1171 JERVIS STREET (COMPLETE APPLICATION)  
DE418742 - ZONE RM-5D

**EXECUTIVE SUMMARY**

**DEVELOPMENT PERMIT STAFF COMMITTEE RECOMMENDATION: APPROVE**

**Levels 05-18 (Typical) Floor Plan**

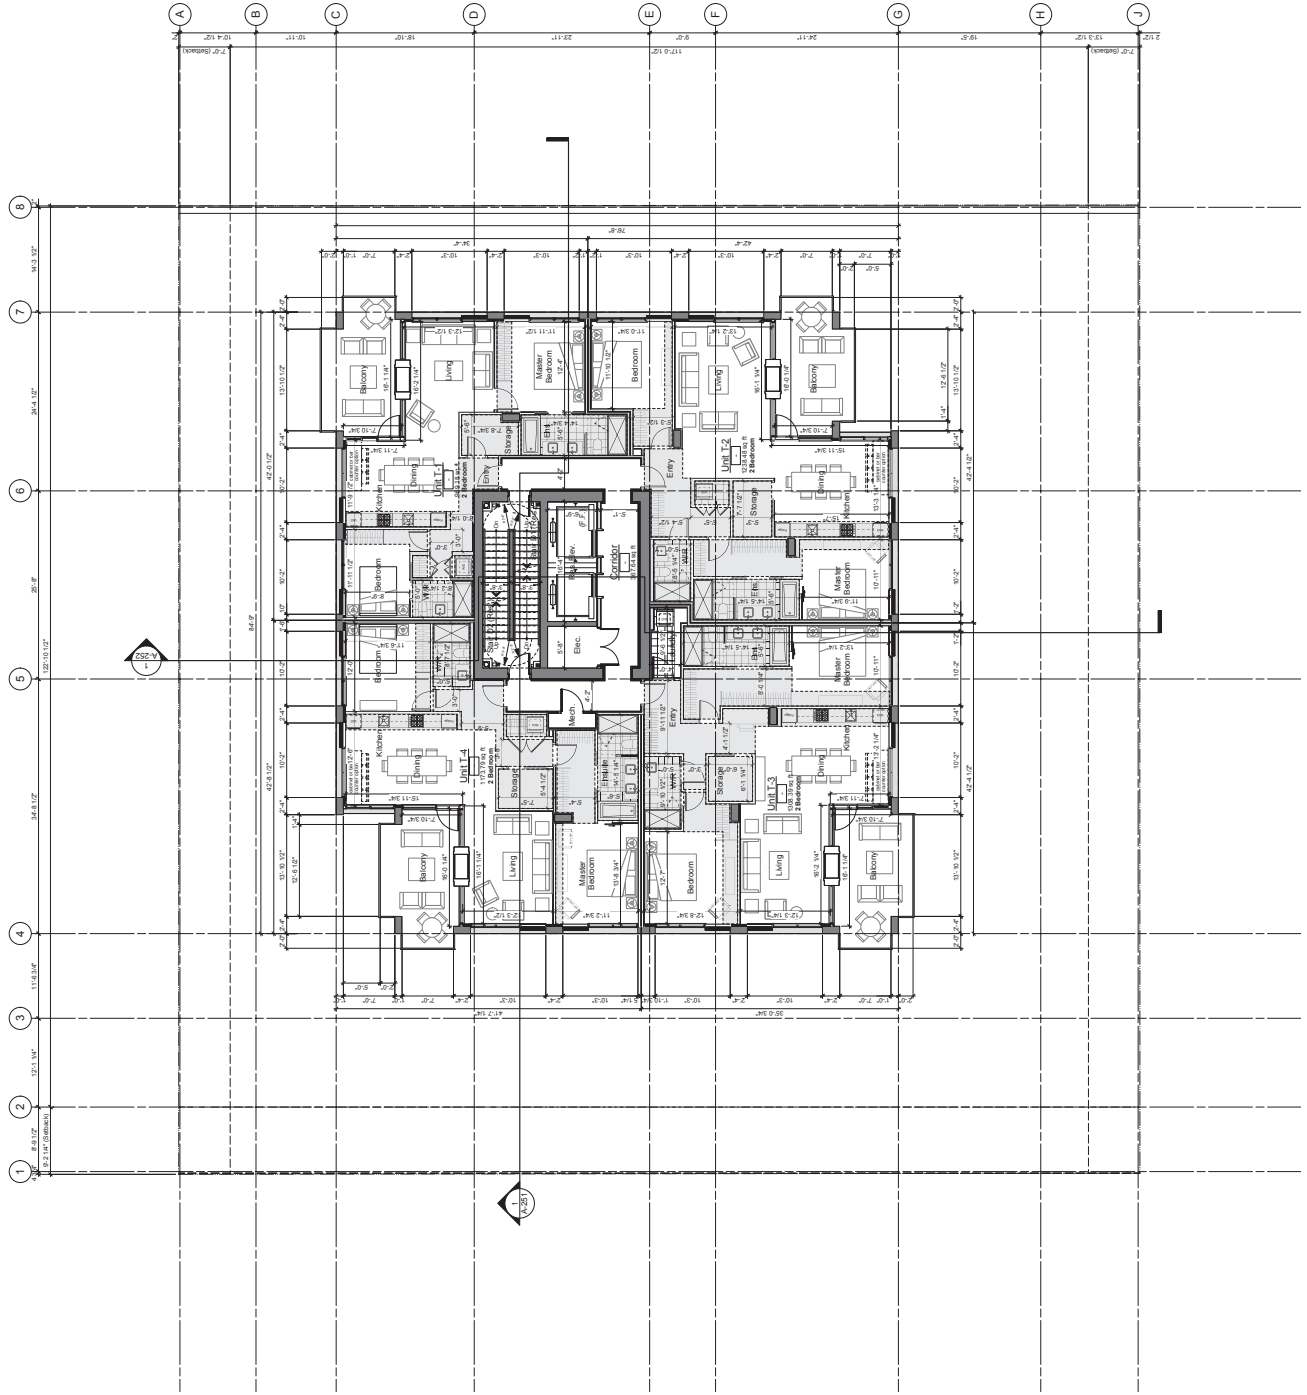
A.1.14 update the Statistics drawing on Page A-001 with accurate data for FSR, Parking, etc.;

1 South Elevation  
Scale: 1/8" = 1'-0"

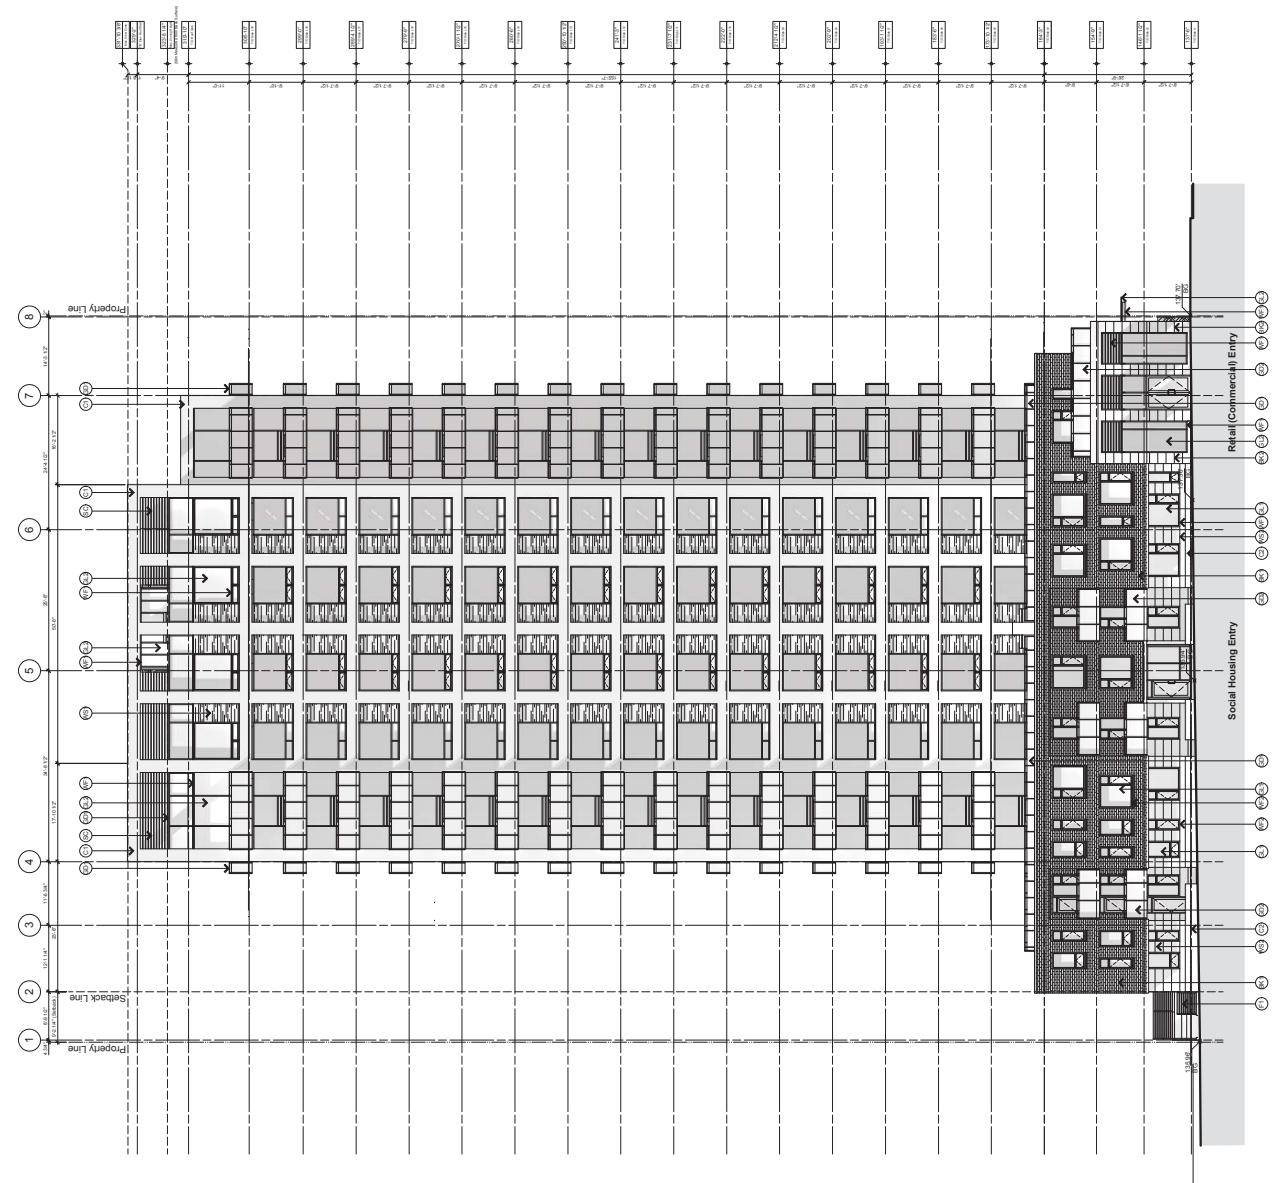
**Note to Applicant:** Further refinement in how the corten steel components of the façade terminate is required on these elevations where the material does not end at the expressed frame. Resolution of the detail will be influenced by the revision of the frame required by Condition 1.1.
